UFH MAN SKETCH GF 4/06/07

GROUND FLOOR PLAN

UFH MAN SKETCH GF 06/06/07

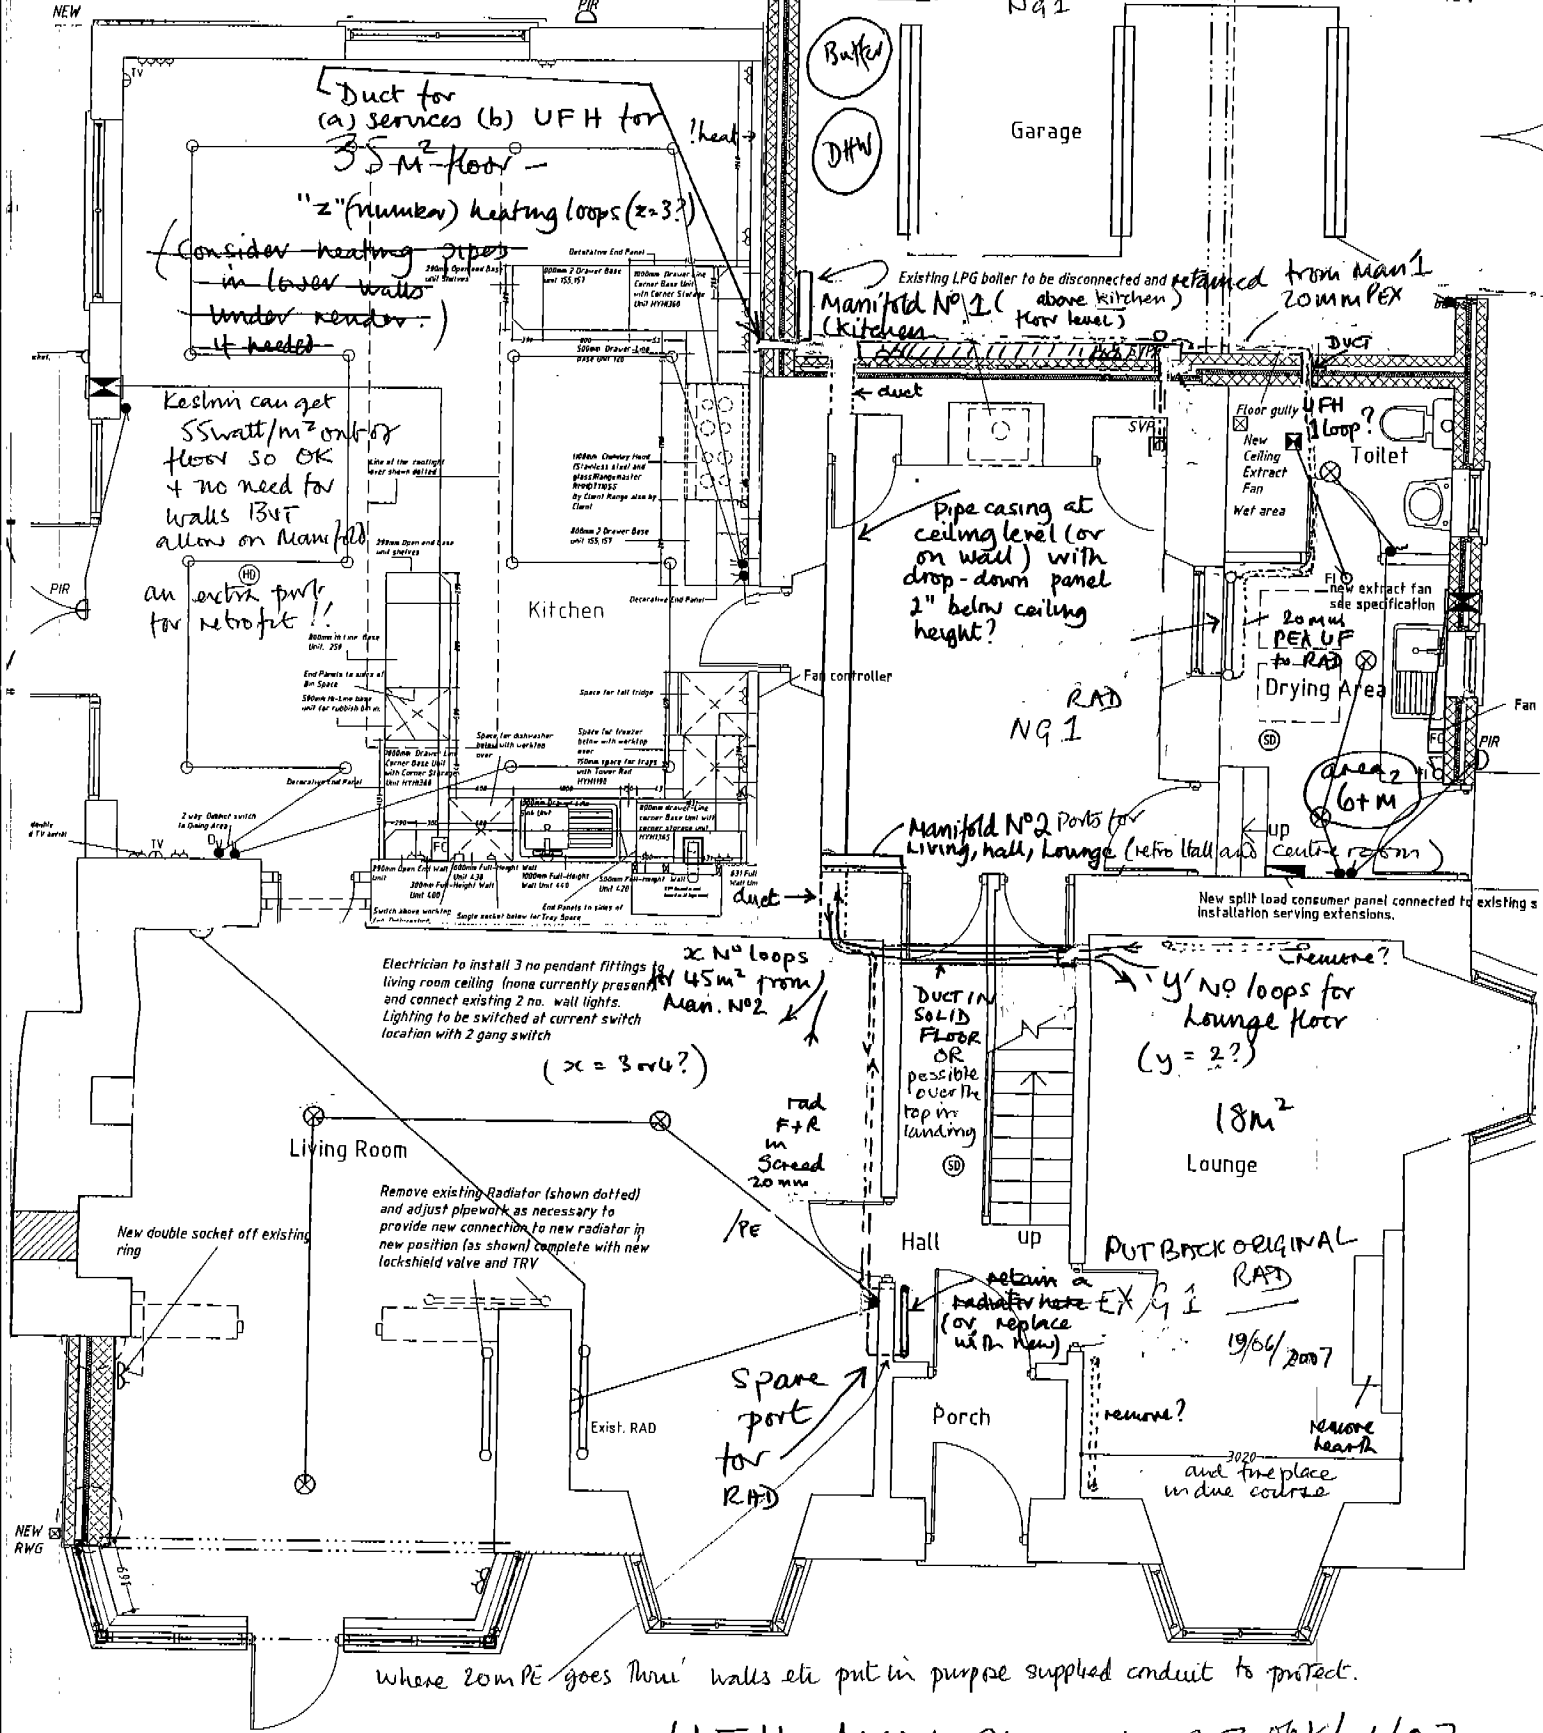
REV. B 6/6/07 Manifold No 2 position

Radiator EX G1 replaced with new, bay retained

Ports indicated
